B-701 (DH) - Box 6

BECHTEL PROJECT NO.: 25409		MACTEC PROJECT NO.: 6468-07-1950		COUNTY: Miami-Dade		GEOLOGIST: J. Liles								
SITE DESCRIPTION: Turkey Point COL		DRILL MACHINE: CME-550 (Miller)		DRILLER: R. White/ J. Dugger/ C. White		GROUND WATER (ft)								
BORING NO.: B-702		DRILL METHOD: Mud Rotary/ Core		SAMPLE METHODS: SPT/Core		0 HR. NA								
GROUND ELEV.: -1.2 ft (NAVD88)		NORTHING: 397,018 US ft (NAD83/90)		EASTING: 875,746 US ft (NAD83/90)		24 HR. NA								
TOTAL DEPTH: 202.5 ft		BORING DIAMETER: 4" to 25.0', 3" to 202.5'		CASING DEPTH: 4" to 25.0', 3" to 122.9'		HAMMER (ID): 140 lb. Auto (M06)								
DATE STARTED: 2/26/08		COMPLETED: 3/6/08		CORE SIZE: HQ3		BITS USED: 2 7/8" Roller Cone								
ELEV. (ft)	DEPTH (ft)	BLOW COUNT			BLOWS PER FOOT					SAMP. NO.	LOG	SOIL AND ROCK DESCRIPTION

B-B-701 (DH) - Box 15

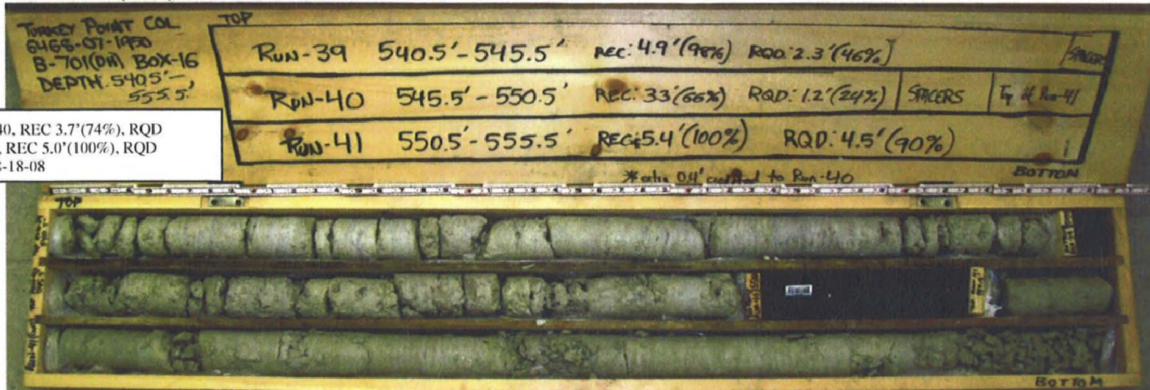
Corrections: Run 40, REC 3.7'(74%), RQD 1.6'(32%)
Run 41, REC 5.0'(100%), RQD 4.1'(8.2%)
JPH. 8-18-08

B-701 (DH) - Box 19

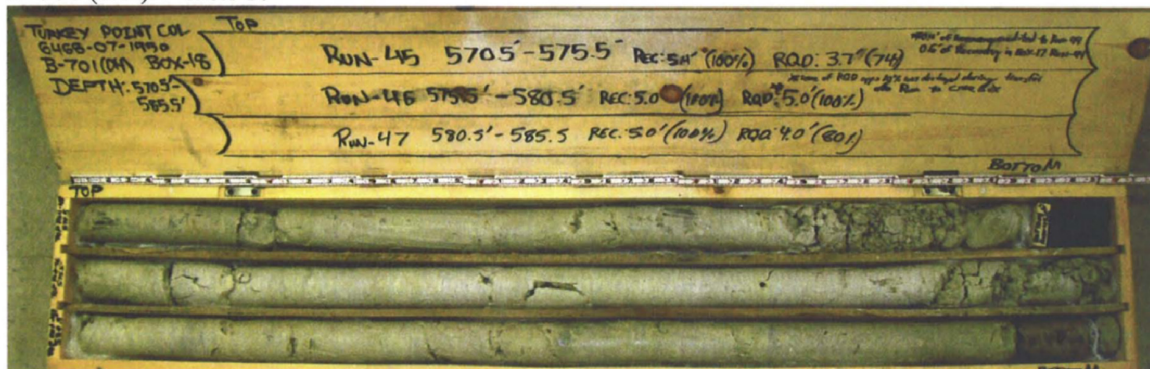
Corrections: Run 53, REC 2.0' (100%), RQD 1.6' (80%)
Run 54, REC 3.0' (100%), RQD 3.0' (100%) JPH, 8-18-08
